ADDENDUM #2

Date:	25 March 2008	
To:	General Contractors	
From:	Bill Bowen, Project Manager, DFCM	
Reference:	Weber State University Hurst Center for Lifelong Learning	
DFCM Project #:	07110810	
Subject:	**Addendum No. 2**	
Pages:	Addendum	1 page
	Substitution Request	16 pages
	Architectural Addendum	38 pages
	Total Pages	**55 pages**

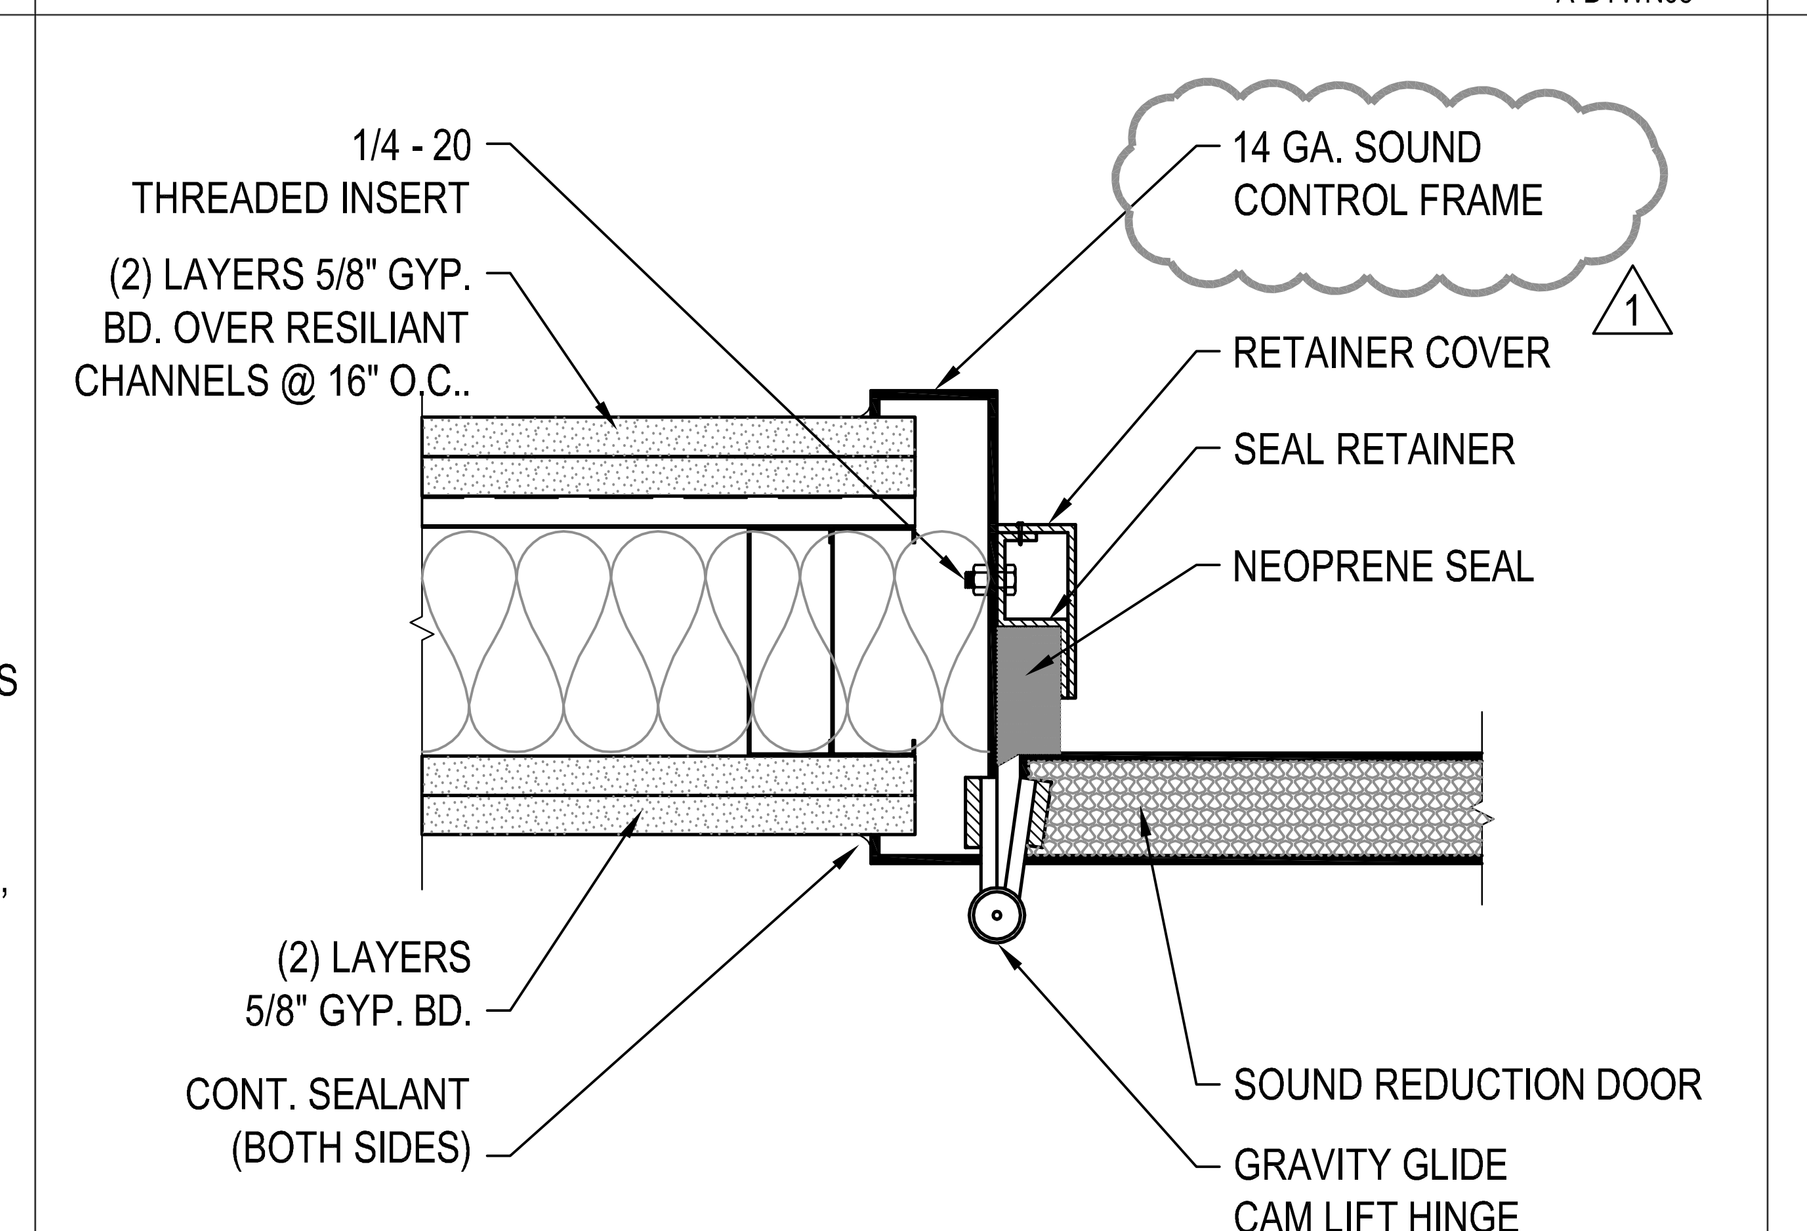
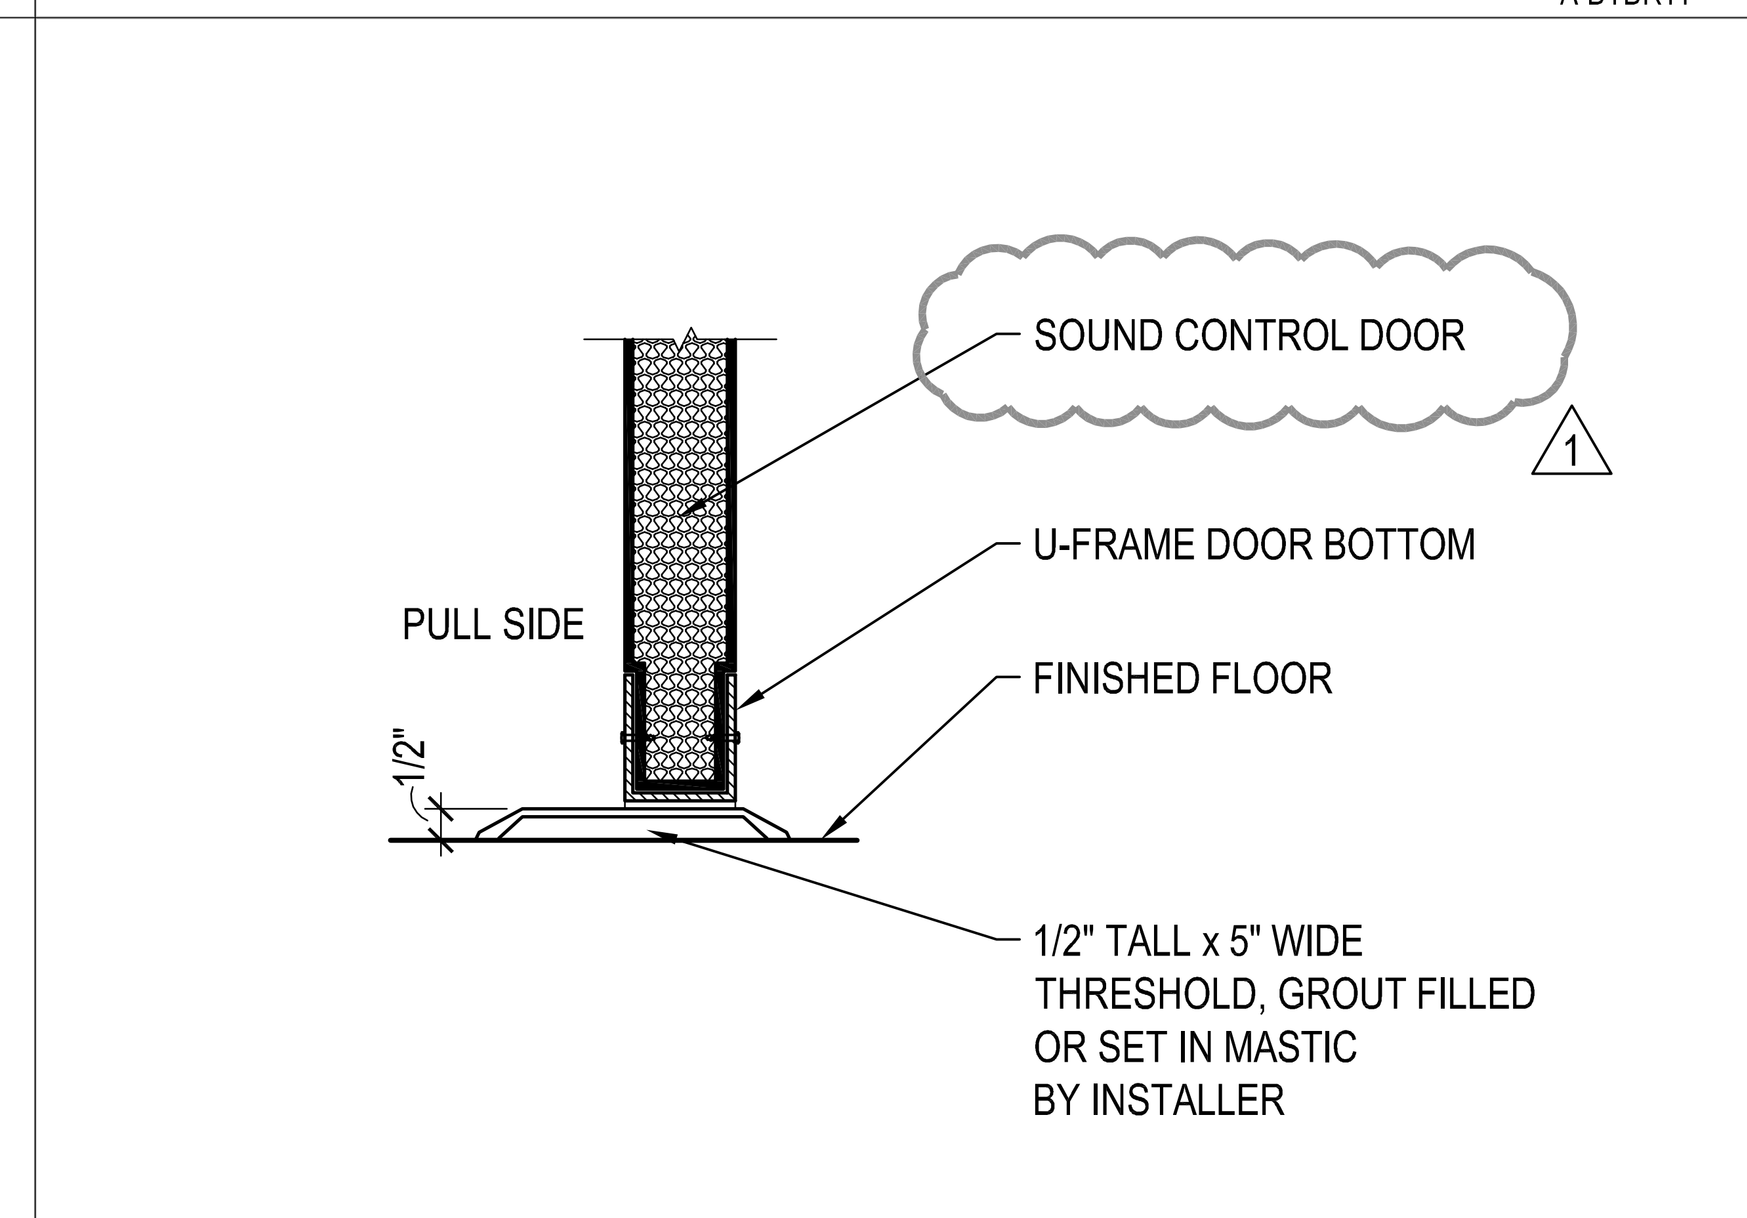
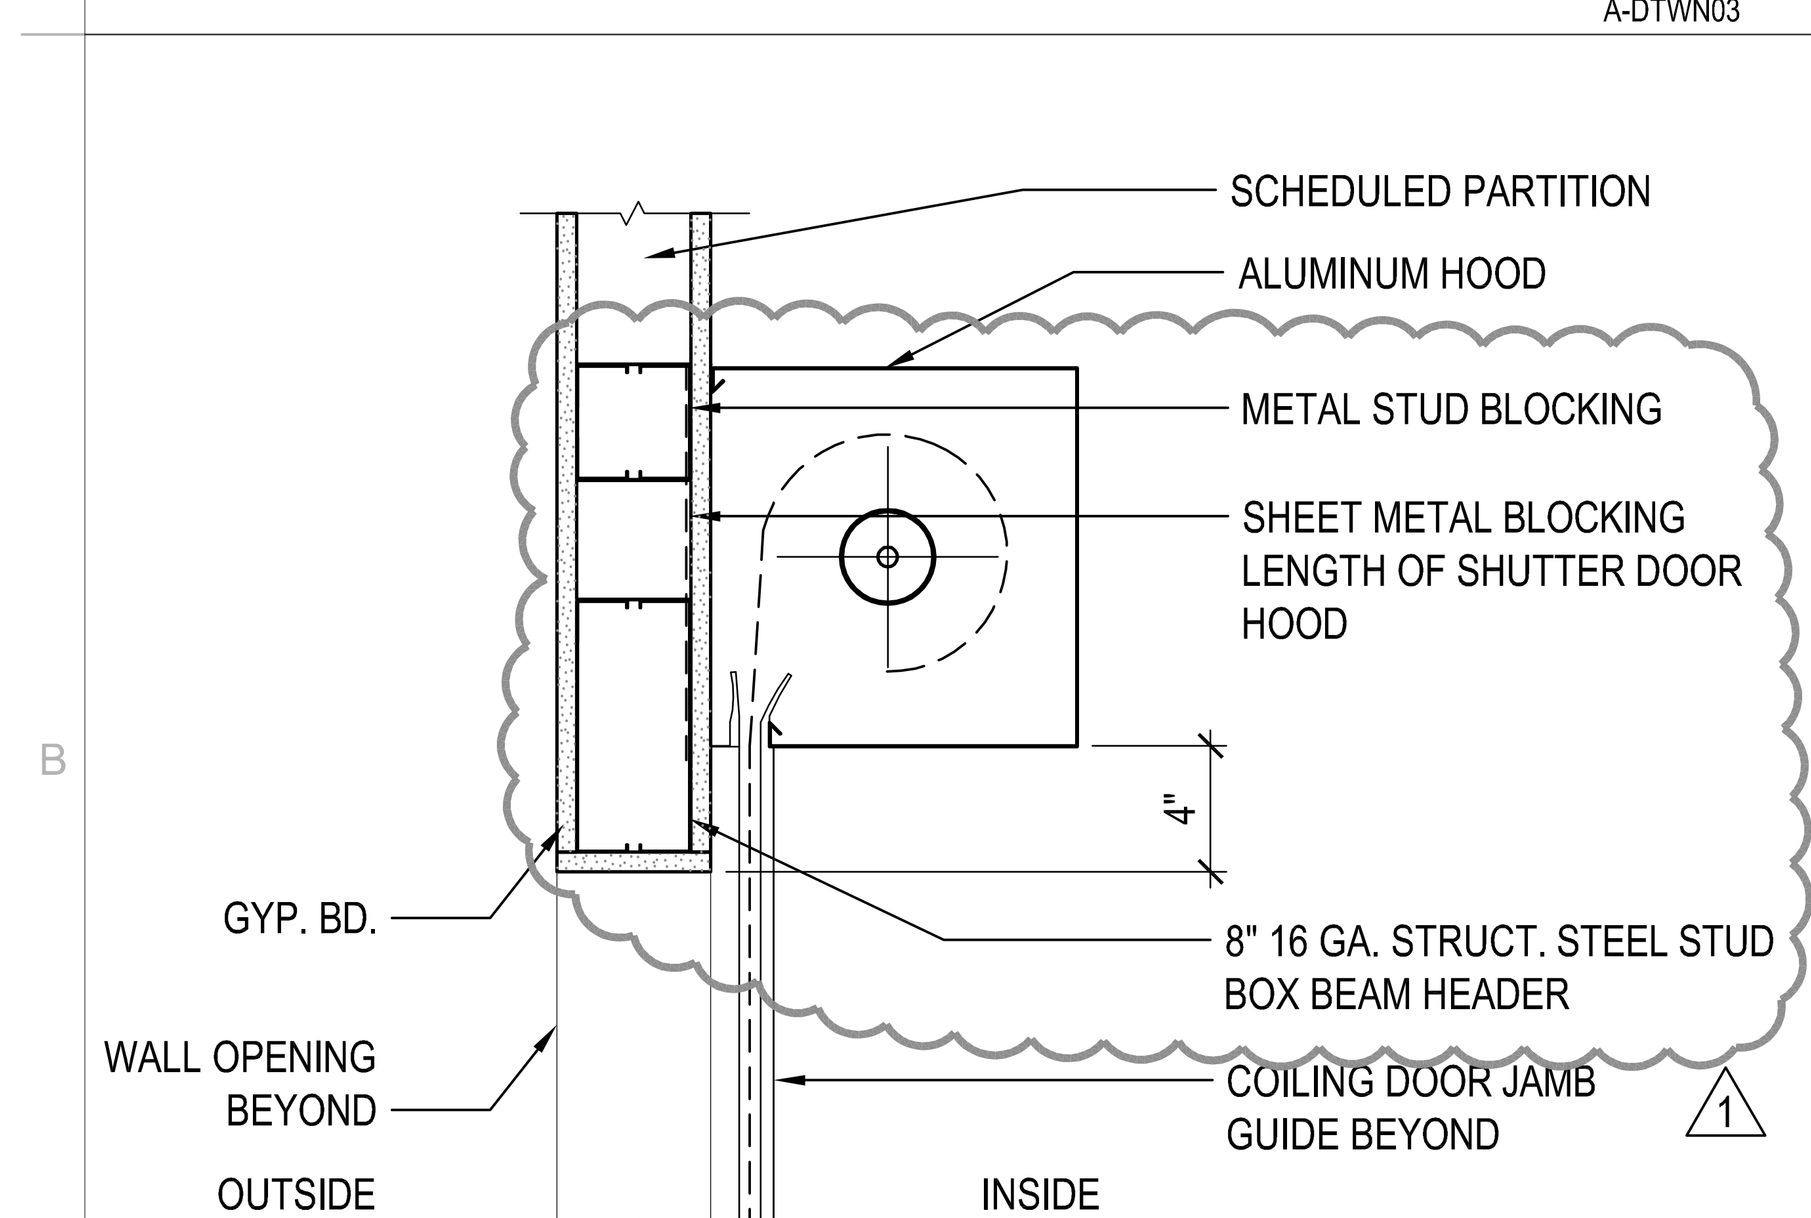
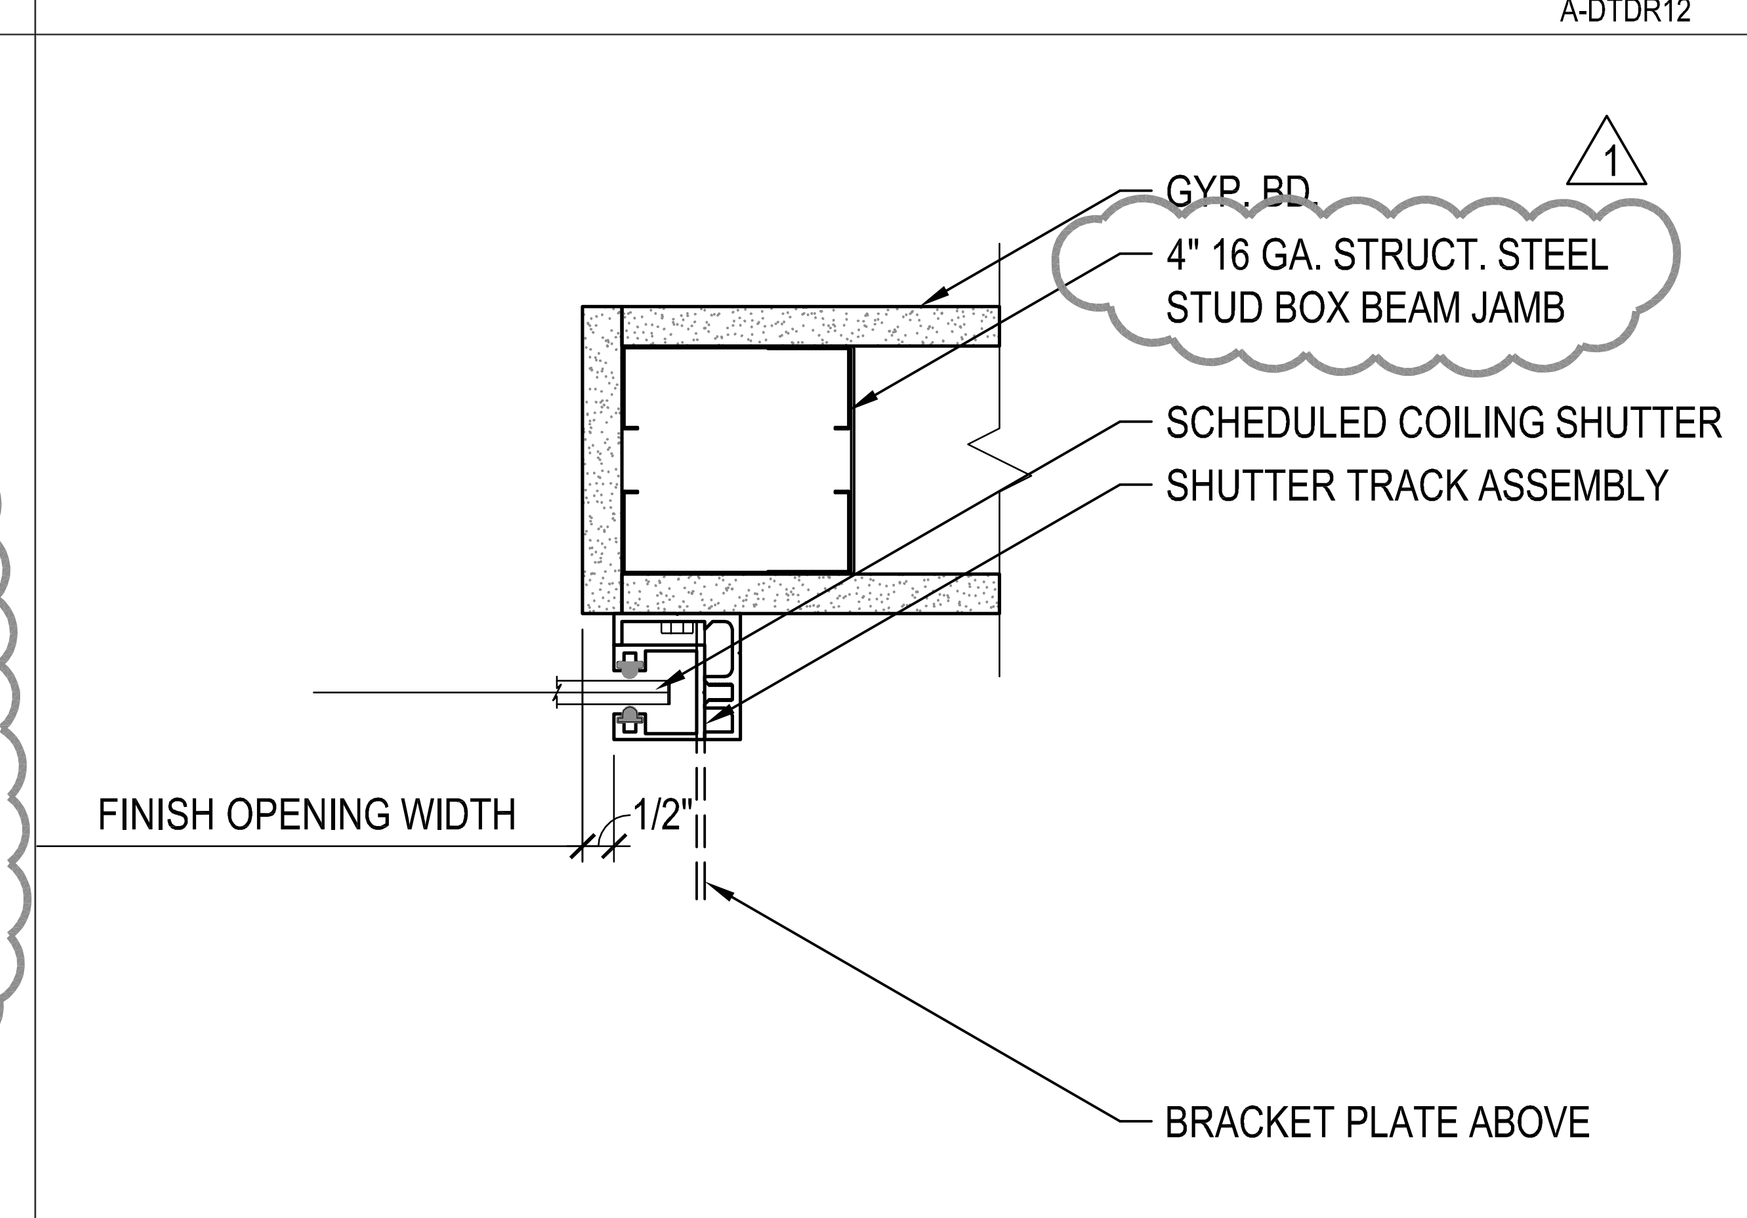
A2.45 Sheet AE520: Replace sheet with new AE520. Delete detail D4. Revised details D2, C2, B1, B2, A1, A2 and A3.
